**Town of Kittery  
 Planning Board Meeting  
 June 22nd, 2023**

**ITEM 3 – 23 Bond Road– Shoreland Development Plan Review**

## 37 APPLICATION & PLAN REVIEW

# LANDSCAPE CONCEPT PLAN

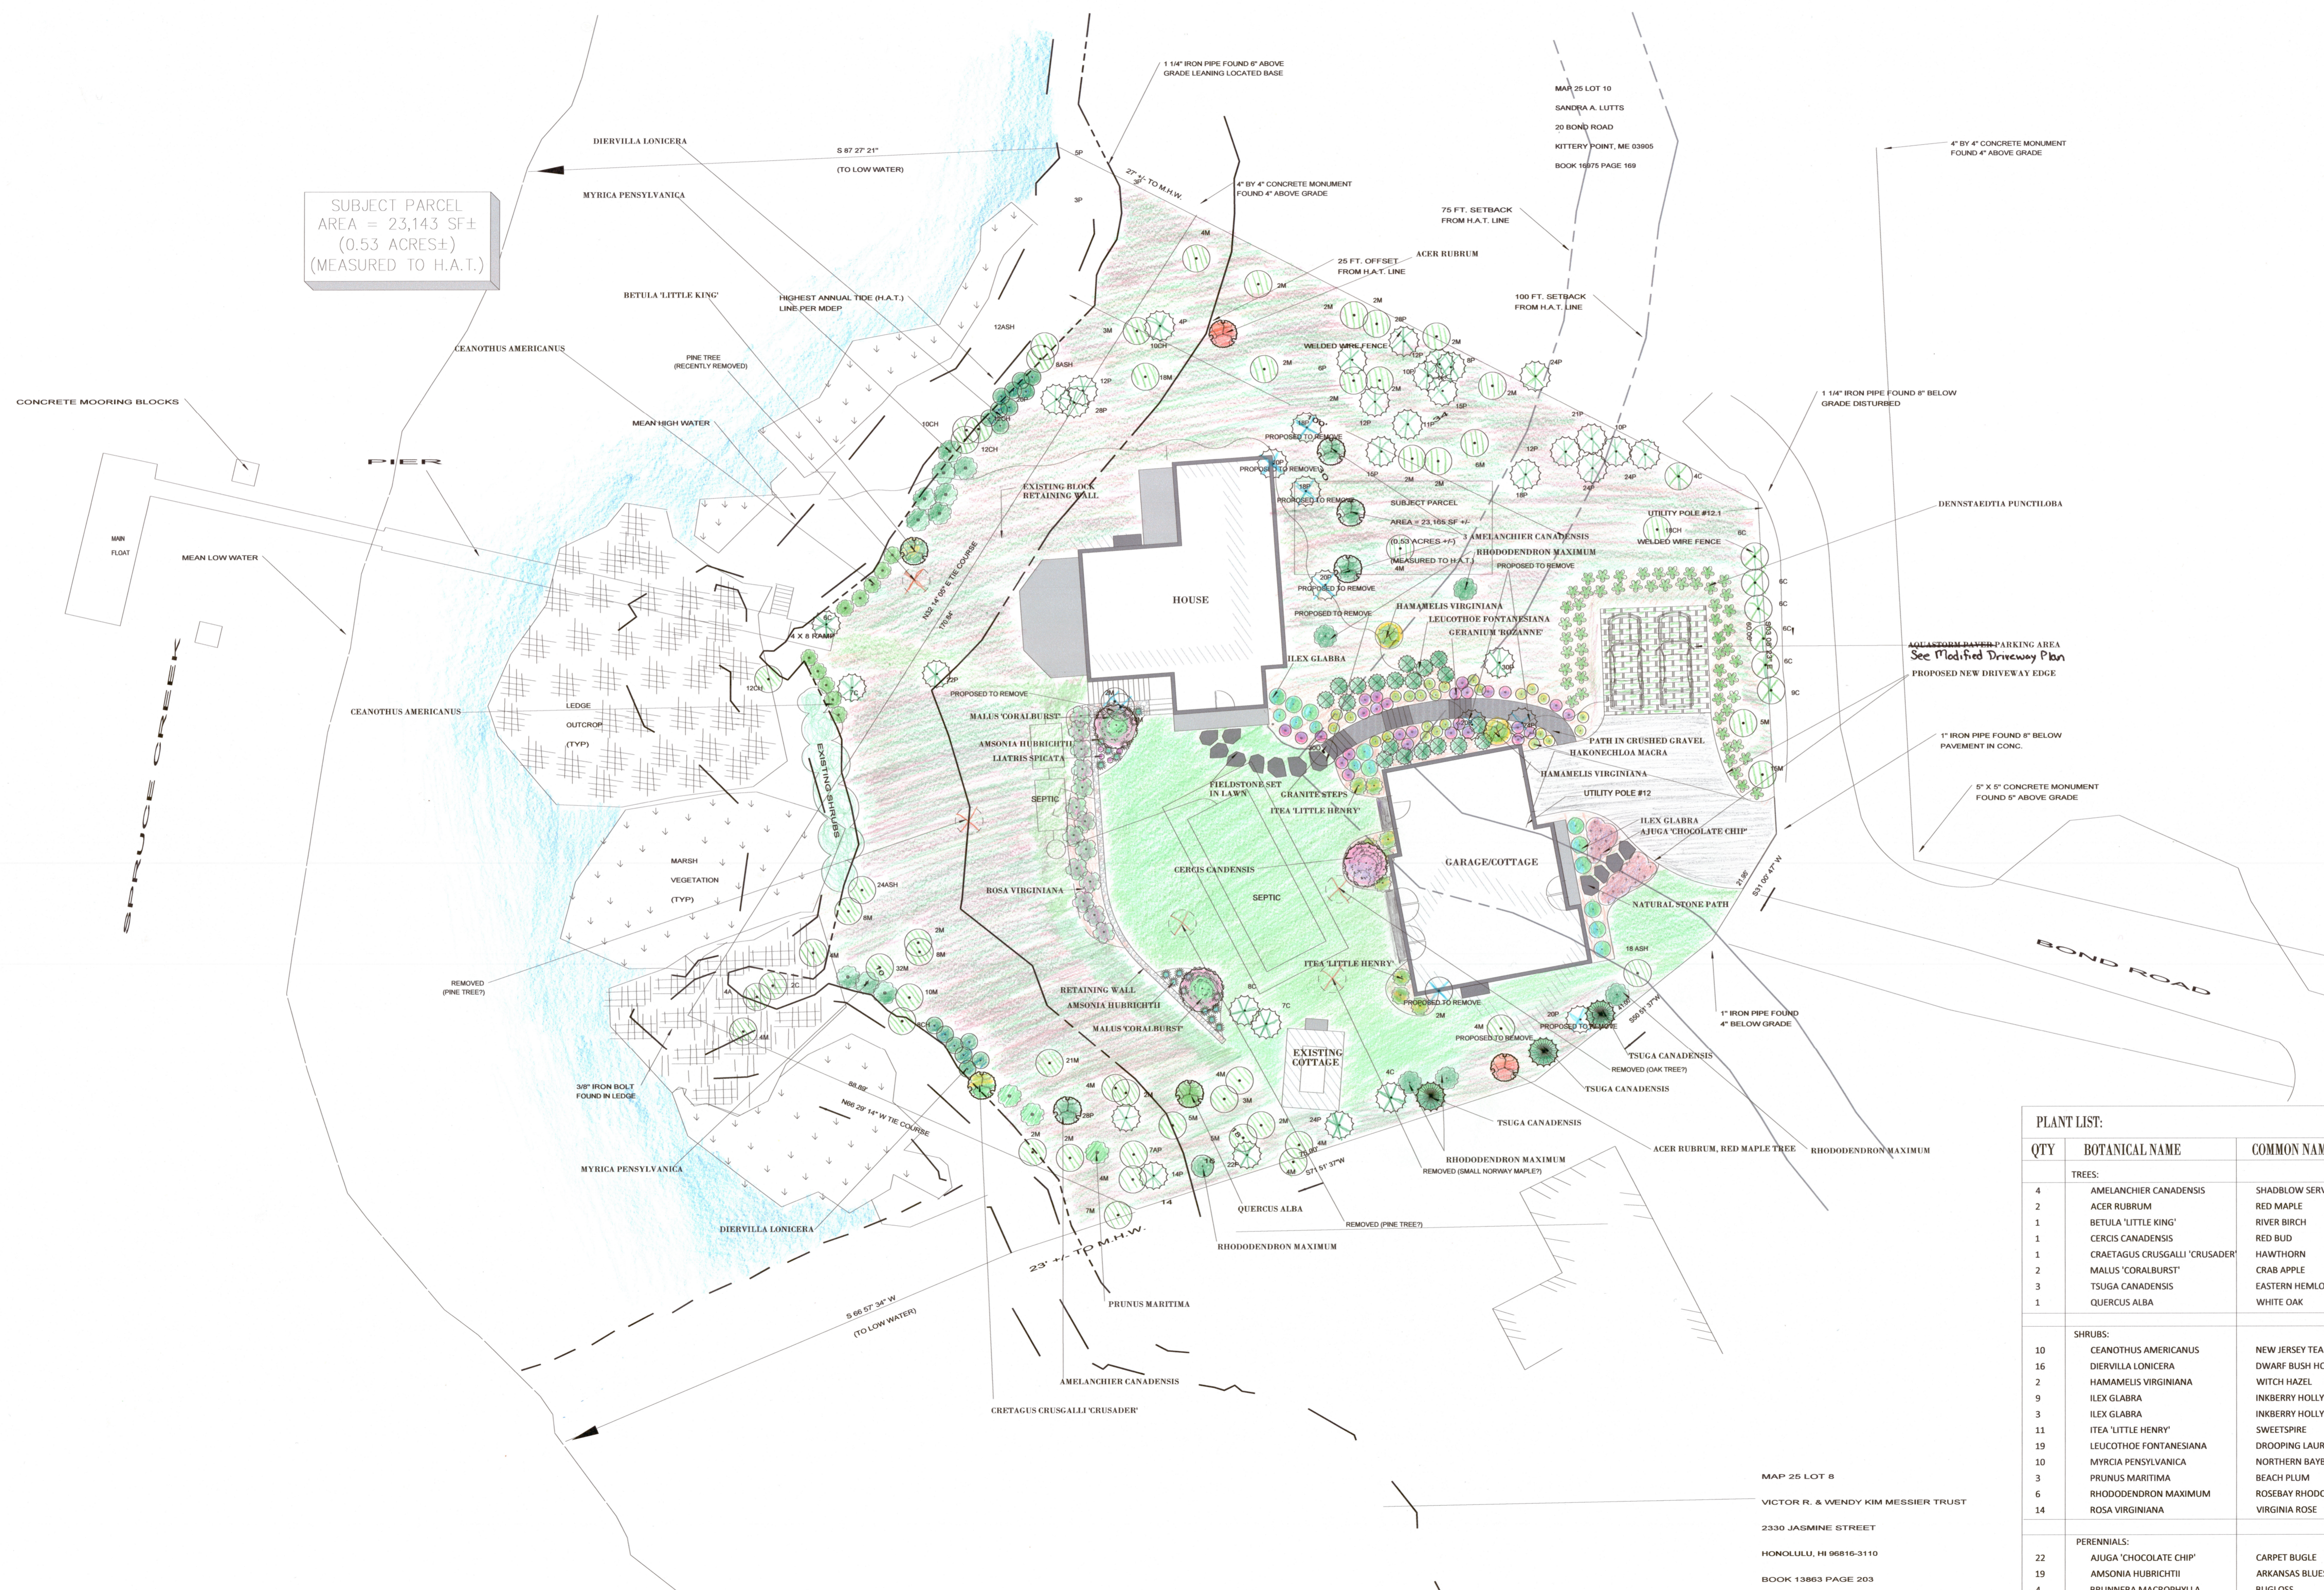
- 39 1. The shoreland revegetation plan is a combination of native shrubs and trees to be planted along  
40 the shoreland and around the proposed home. The new vegetation will provide food and habitat  
41 for wildlife, enhance aesthetics, and reduce the risk of erosion.
